Subject: FAST IDLE DURATION CHANGED	Bulletin No: 01-027/08
	Last Issued: 4/16/2008

2009 RX-8

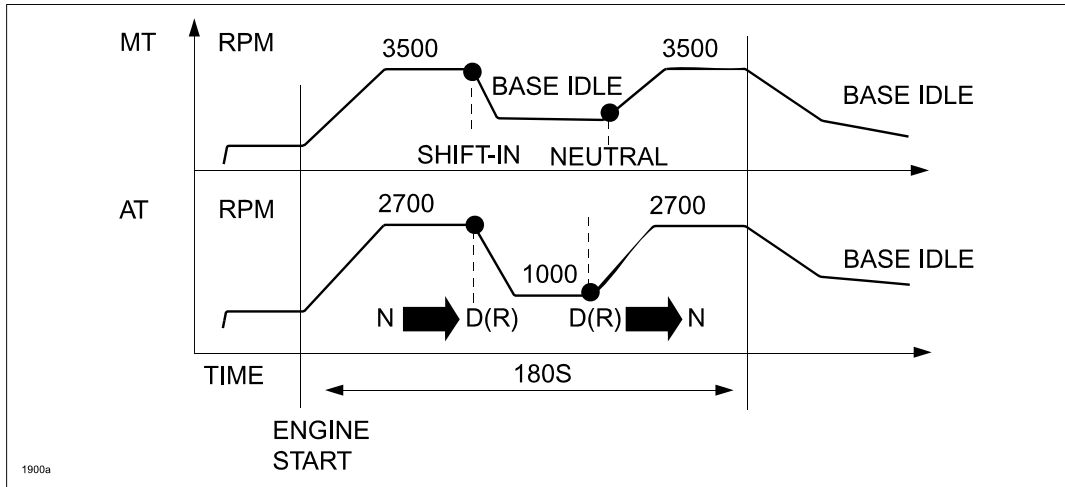
The original setting of fast idle duration at a cold engine start-up has been changed since start of production of the 2009 RX-8. This service bulletin is for aid in understanding the differences and advantages between previous and current fast idle duration.

Model	Fast idle engine speed (RPM)	Fast idle duration (seconds)	Activating anti-freeze temperature by C (F) below:
2004-2008 MT	3500	10	-10 (14)
2004-2008 AT	2700	15	-10 (14)
2009 MT	3500	180	-5 (23)
2009 AT	2700	180	-5 (23)

The purpose of this design change is to help engine start-ability at port facilities or dealer lots where vehicles are frequently started cold, moved for short distances and then tuned off.

If the vehicle is shifted into Drive or Reverse (AT) or any gear but neutral (MT) during the 180 second fast idle duration the engine RPM will drop to 1000 RPM (AT) or base idle (MT) to prevent sudden movement due to the high idle speed condition as outlined in the graph.

Before turning the engine off, allow the idle to stabilize after the 180 second fast idle duration. This will ensure the engine will start during the next cold engine start-up.
